RE: PLANNING SUBMISSION IN RELATION TO THE STATE SIGNIFICANT DEVELOPMENT APPLICATION – SSD-11606719

PROPERTY AT: 1 KANGAROO AVENUE, EASTERN CREEK (LOTS 1-2 DP 1145808, LOT 2 DP 1247691, LOT 7 DP 1200048)

Figure 2 Assessment locations (Source: SSD-11606719 Environmental Impact Statement)

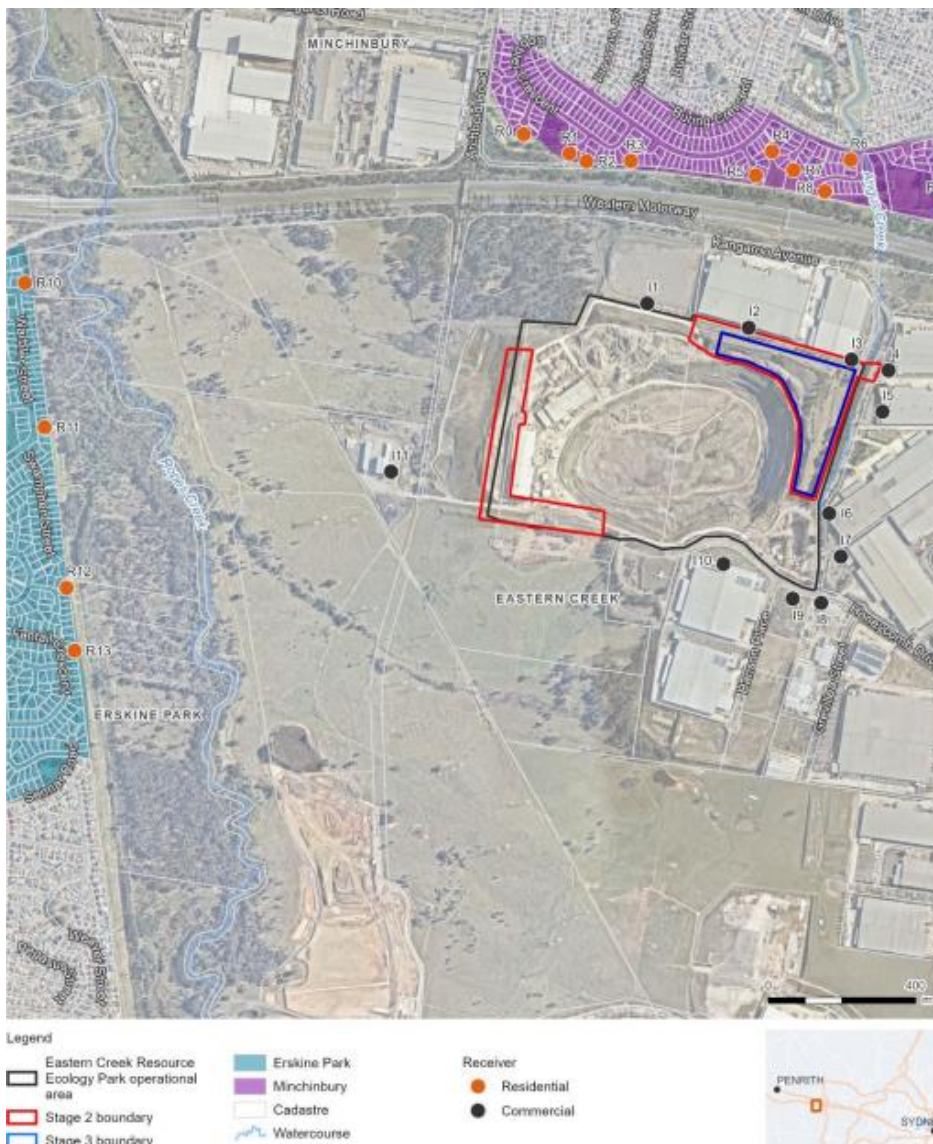
This objection has been made against the Proposal based on the observations and information provided in the *Noise and Vibration Impact Assessment Report*. There is potential that there will be impact of noise on the adjoining land owned by Lendlease due to the proposed works as:

- The noise associated with the intensification of the use of the Site will impact on the acoustic amenity of the workers in the existing commercial and industrial facilities in the area, including the Lendlease owned land.
- It is unclear whether the road traffic noise analysis considers the proposal in its respective stages. This should be clarified in the NVIA.
- It is noted that the approved hours of operation of the REP involves 24 hours operation for certain components of the operation, as well as truck deliveries from 5:00am to 9:00pm. The

- Sensitive educational receivers such as James Erskine Primary School and Erskine Park High School located to the west of the Site, as well as Minchinbury Public School to the north of the Site have not been identified.
